# Cymru Scaffold Inspections

INSPECTION OF: Site Scaffoldings

SITE: Aberavon House, Port Talbot, SA13 1 PB

UNIQUE IDENTIFICATION NUMBER: AS 260 Rear Elevation

## REAR ELEVATION

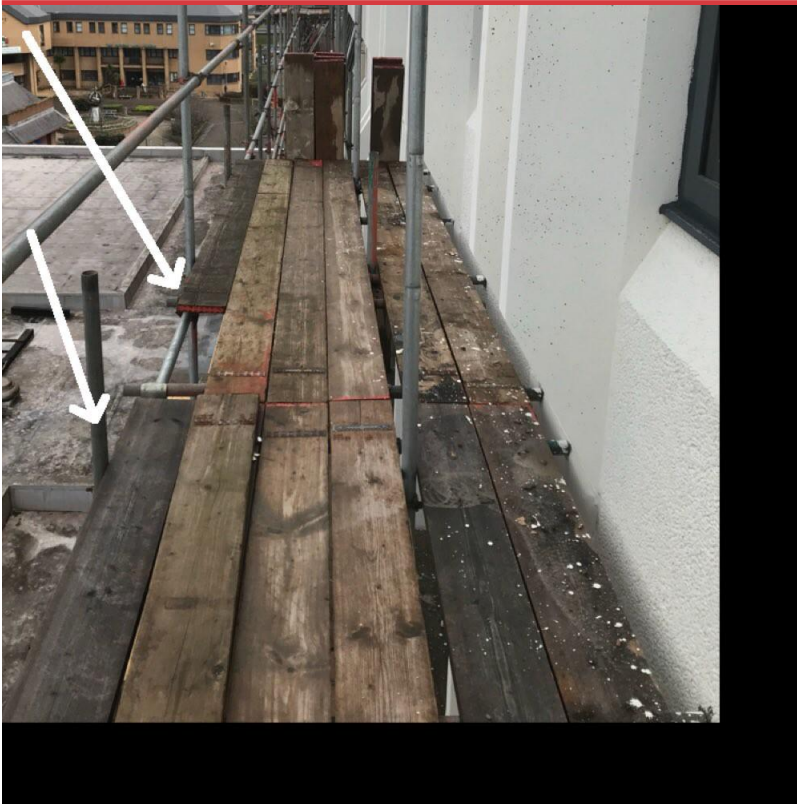
The scaffold on the Rear Elevation has sufficient ties in order to meet the requirements of the Design and TG20:13

Alterations and modifications were being performed on the scaffold on the Rear Elevation during the scaffold inspection

## REAR ELEVATION

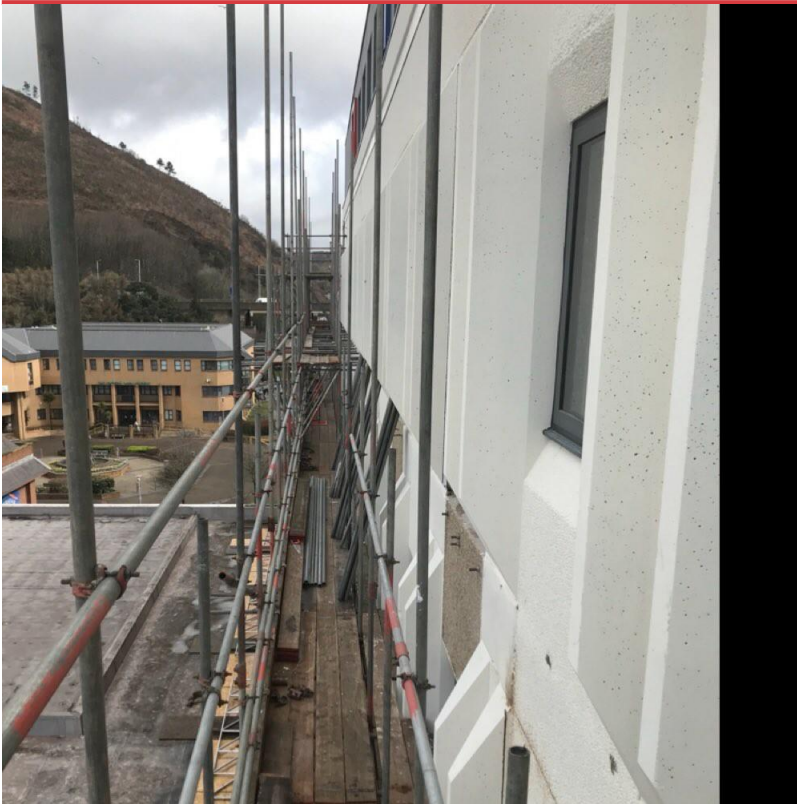
The scaffold materials need to be removed from the Working Lifts prior to Contractors using the Rear Elevation.

All modifications and alterations need to be carried out prior to next use of the scaffolding.

### **REAR ELEVATION**

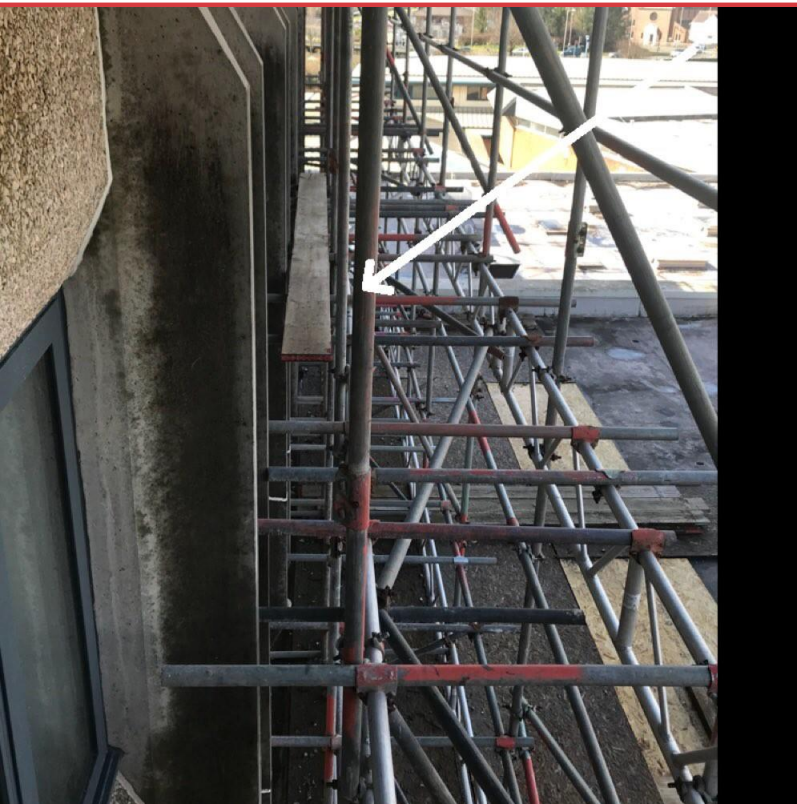
Scaffold materials need to be removed from the Working Lifts prior to the next use by the Working Parties

### **REAR ELEVATION**

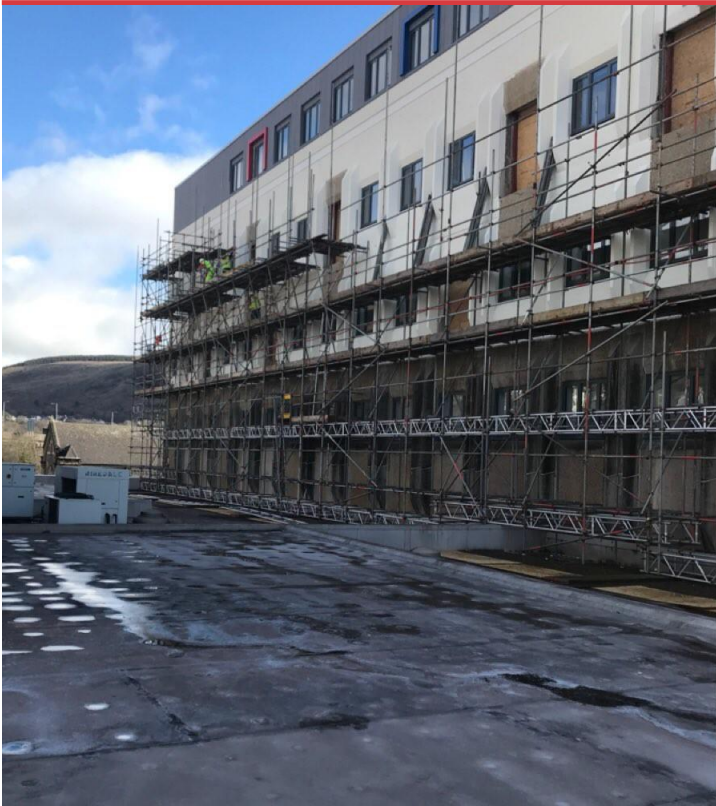
A scaffold board has been left on a non Working Lift that needs to be removed in order to prevent it blowing
